AGENDA ITEM 6

RESPONSE TO CNPA

Response to Cairngorms National Park Authority

This document responds to the Cairngorms National Park Authority's (CNPA) letter, dated 28th October 2014, requesting further information on a number of topics relating to the River Pattack Hydro Scheme planning application [Application Reference 14/02344/FUL] [CNPA Reference PA-272].

Figure 9: Section A-A looking south through track to incorporate pedestrian footpath

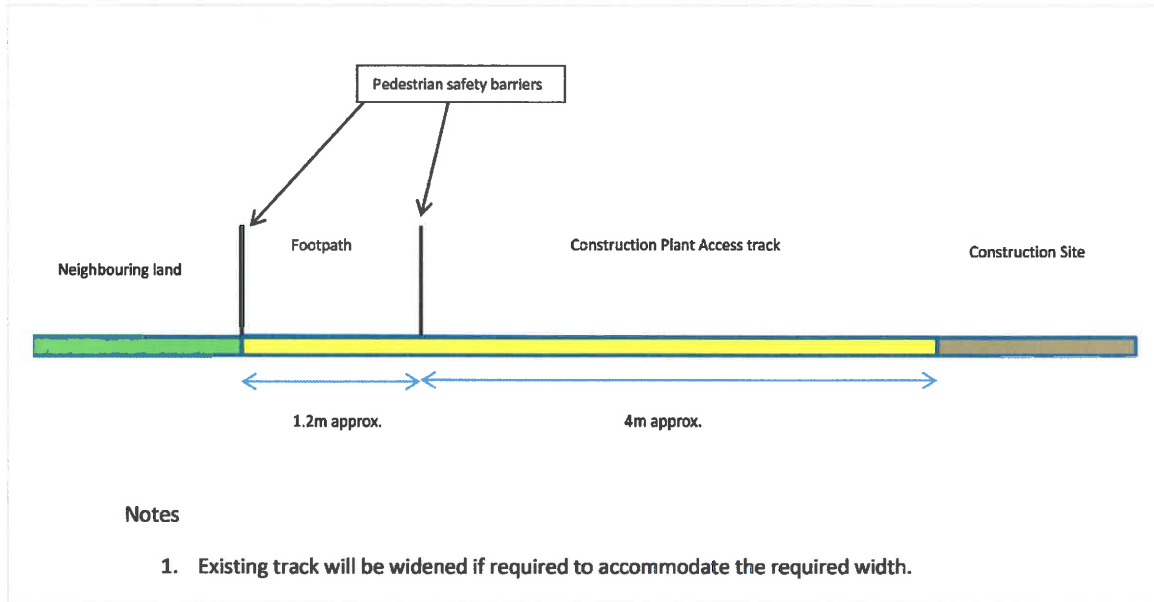
Objection 9: Public Access – confirmation that public access and core paths will be unaffected by the proposed development, in particular the core path running from the Dalwhinnie/Ben Alder area to Pattack.

3. There is a short stretch of existing track that will likely be used for both plant access and pedestrians near to the track junction in the middle of the site and is circled in red on the plan (Figure 8). A typical section through the track is also included (Figure 9) to show this arrangement. It should be noted that the existing estate track may require some improvement and/or widening to accommodate these requirements.

Wider Powerhouse Location Plan - Site 1
1:500

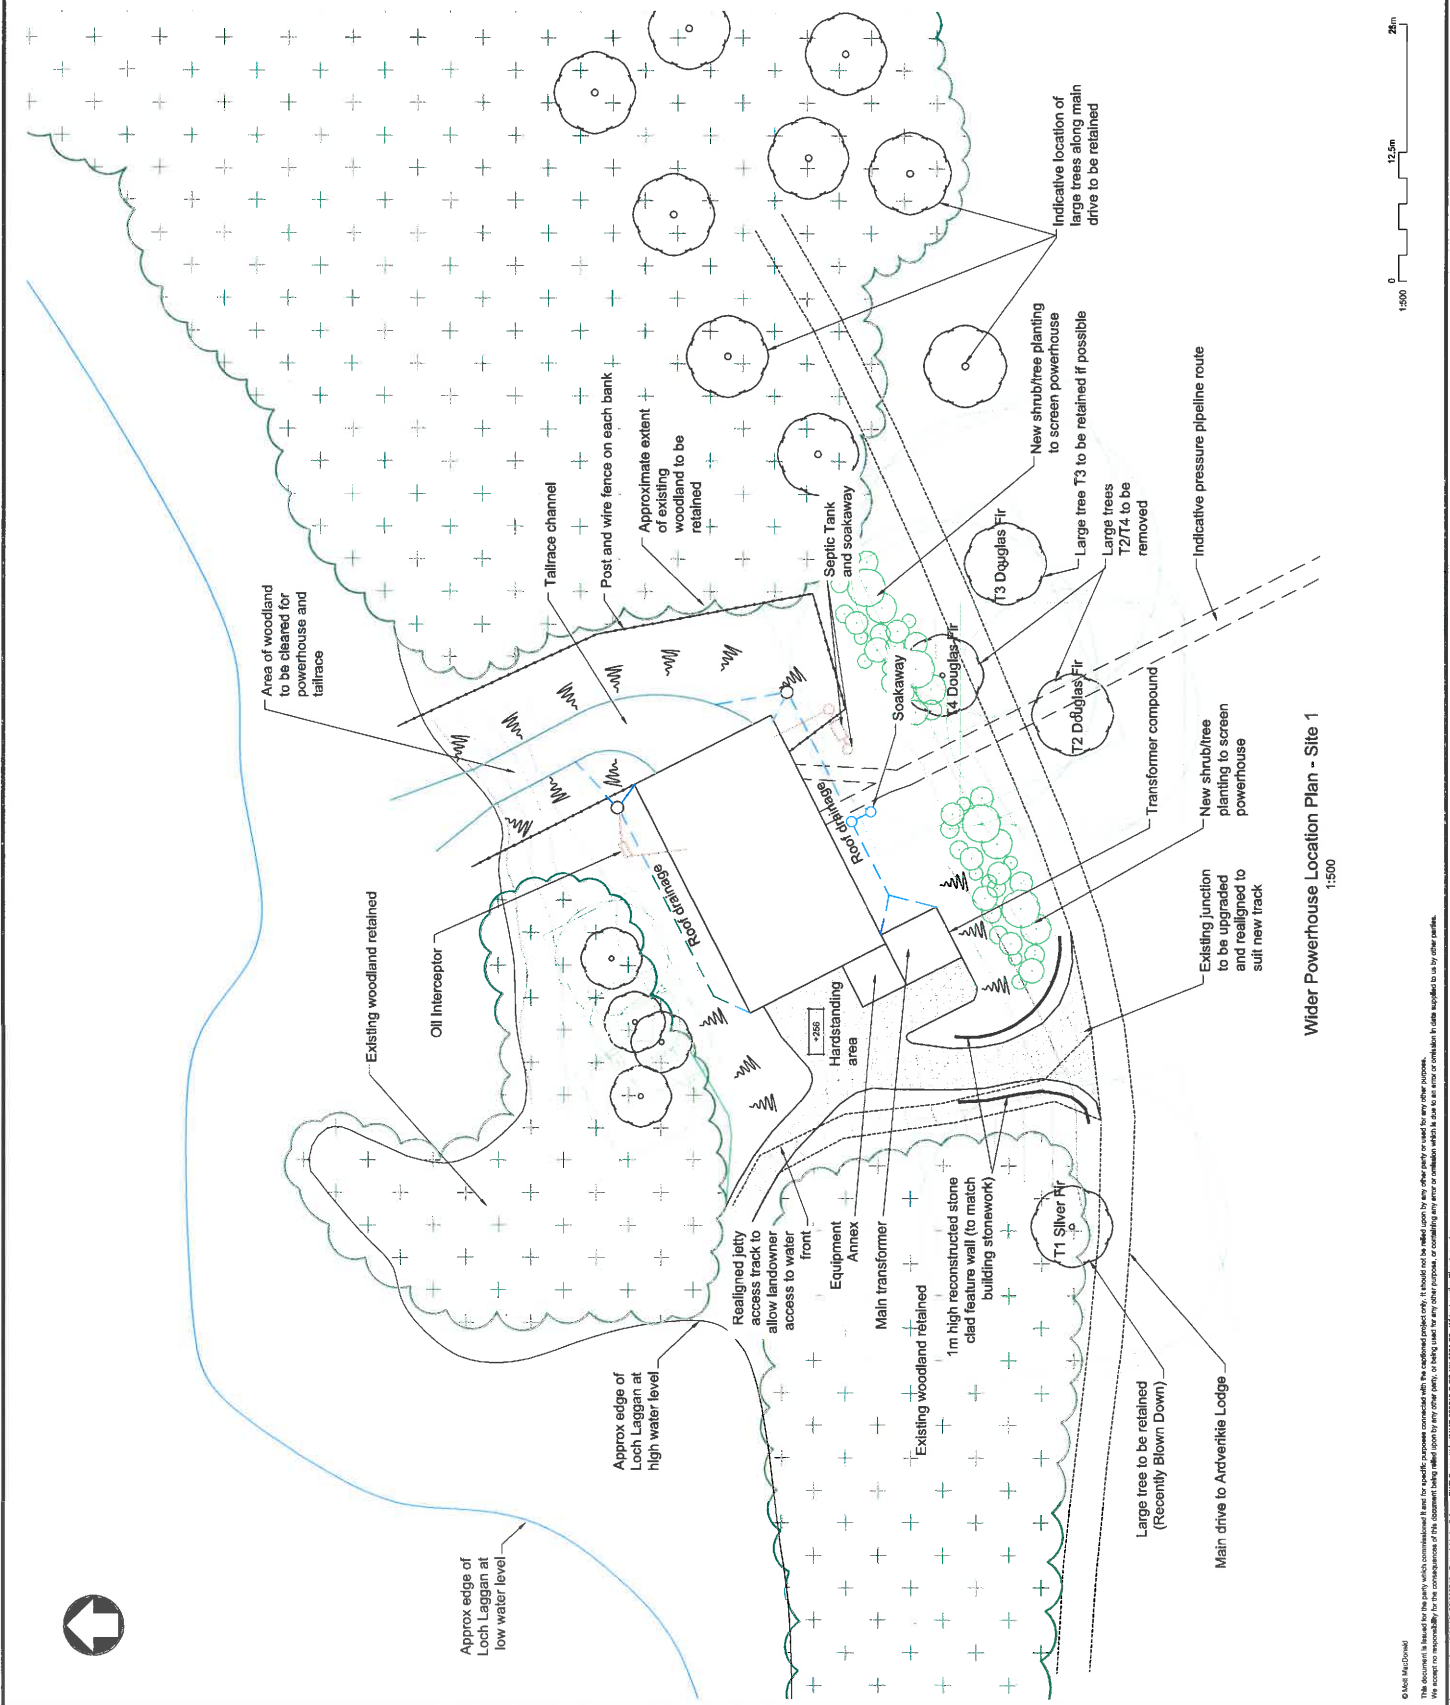
Objection 6: Powerhouse – details are required of the proposed method for the protection of trees identified for retention, and design and finishes of the building (walls and roof) to reflect those of other buildings on the estate.

Engineering Drawing 12 shows details of which areas of trees should be retained, removed or replaced. Those to be retained will be protected through suitable construction exclusion zones, sized to encompass the root protection area of each tree. This would be done by using fencing with suitable signage, all managed by the contractor. If the powerhouse excavation exposes any clashing tree roots then they will need to be curtailed adequately to allow construction to continue, with any consequential deterioration in the condition being monitored from that point onwards. If any root curtailed tree showed deterioration over time it may need to be felled to protect the powerhouse structure.

Powerhouse Photomontage

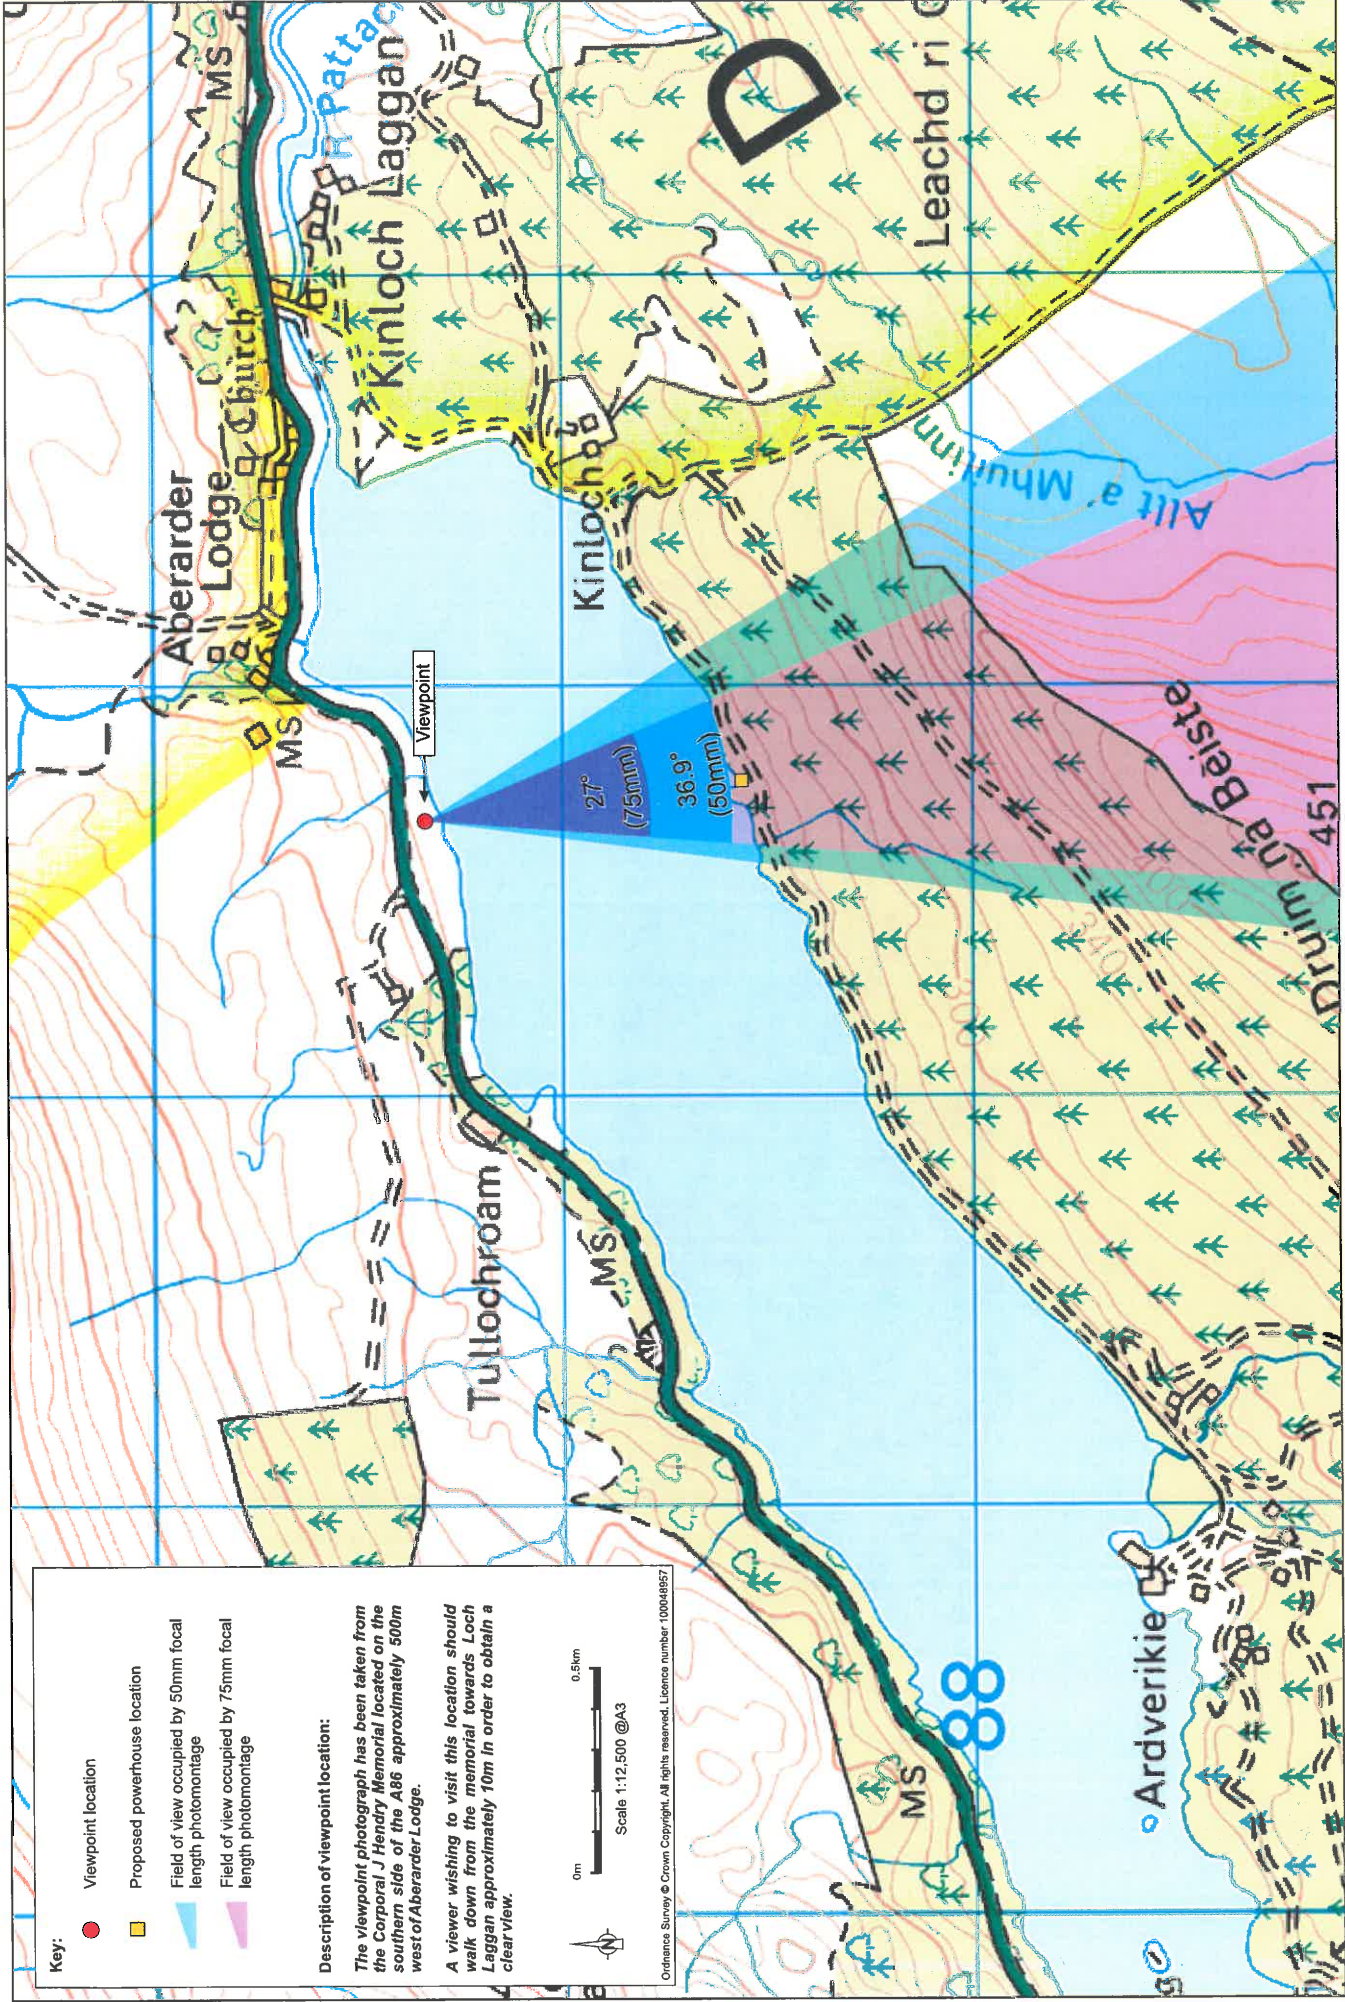
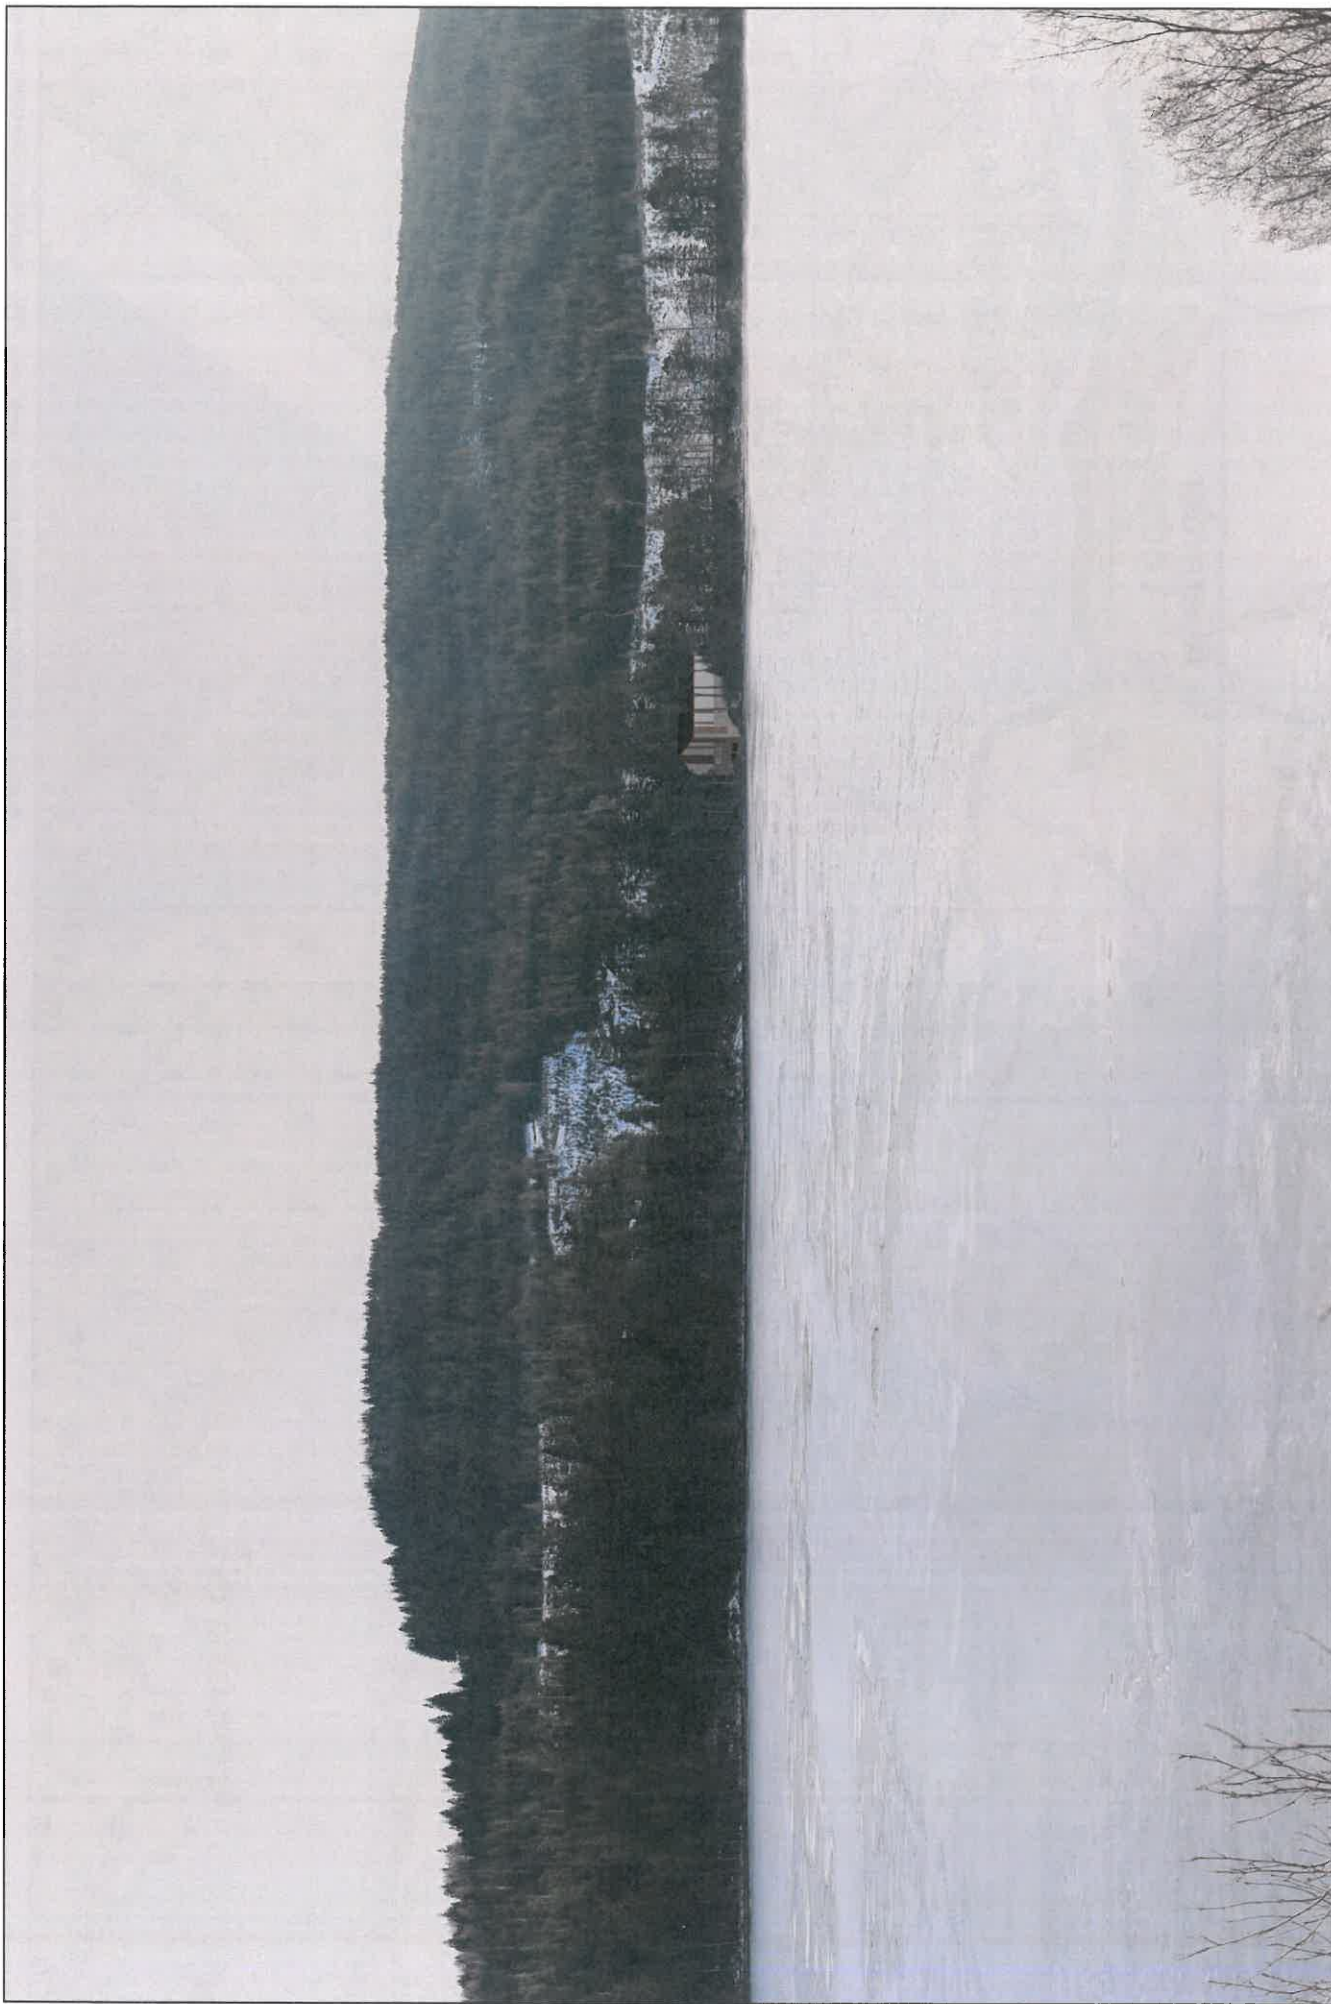
Further detail from CNPA: The CNPA Planning Committee were keen to ensure that any visual impacts arising from the new powerhouse would not have an adverse impact upon the National Park and that suitable material be submitted to show this.

Also attached, is a new photomontage (Appendix B) created for CNPA showing how the powerhouse might look when viewed from the main road over the other side of Loch Laggan (this was also included in the recent Addendum of Information submitted to Highland Council). The powerhouse building is located approximately 800m from this nearest public road - the scheme having a "slight adverse" long term visual impact during operation from this viewpoint (Chapter 11 and Figure 11.2 of the original Environmental Statement).
